July 2, 2020

**FROM:** Colleen Hall, Planner/GIS Technician, Department of Building & Planning

**SUBJECT:** Tentative Sketch and Open Space Preservation Subdivision Plan – 1064 & 1080 Mt. Pleasant Road, Bryn Mawr, SD# 3859, Ward 6

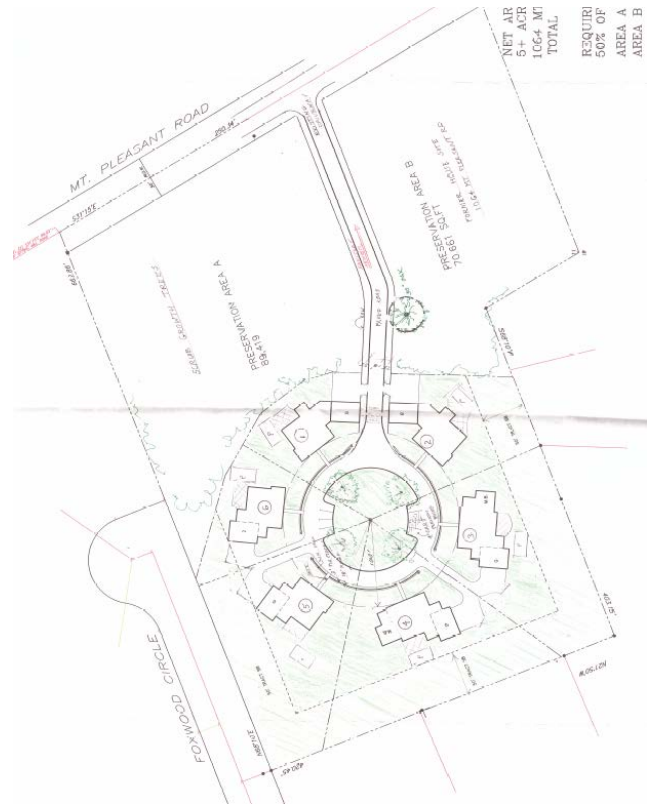
The applicant has provided an analysis for the connection to the Foxwood Circle cul-de-sac bulb. Due to the steep vegetated embankment leading up from Foxwood Circle into the site, the roadway grades would exceed the required 3% grade within 50 feet of an intersection. The connection would result in extensive cuts through the site regardless where placement of the roadway occurs, in order to achieve the desired grade for a newly constructed roadway. The applicant's engineer has provided their professional opinion that providing a connecting roadway from Mt. Pleasant Road to Foxwood Circle is impractical based upon the current site topography.

As stated in the applicant's analysis, neighborhood connectivity does not have to focus solely on connecting roads and vehicles, and staff concurs with this analysis. The proposed plan with its surrounding open space is able to accommodate a private trail to provide pedestrian connections to the adjacent neighborhood. This would preserve the character of the Foxwood Circle neighborhood and facilitate safe connections with the added benefit of the experience of a naturalized landscape. Staff will incorporate a condition for this design for the pedestrian connections be provided with the Preliminary Plan submission.
